Minutes of T11 HIPPI SWG, and HNF - Technical Committee (TC)
June 9-10, 1997
Seattle, Washington

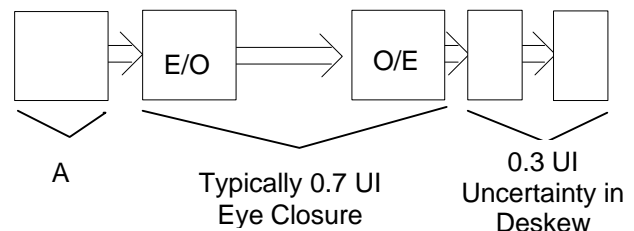
Steve Joiner of Hewlett-Packard used the following figure to talk about the optical jitter problem.

The key problem is that the typical summation of the normalized jitter factors results in a number greater than one. Steve, and Hansel Collins, suggested that this effect can be reduced via filtering and cleaning the clock signal at the receiver, e.g., with a SAW filter, prior to de-skewing. The next challenge is to verify that the remaining jitter factors sum to a value less than one. Hansel pointed out that the SuMAC skew compensation circuitry essentially used a tapped delay line to adjust the skew value. Hence, there are discrete points where the received signal can be sampled, not the continuous range offered by most clock recovery schemes.
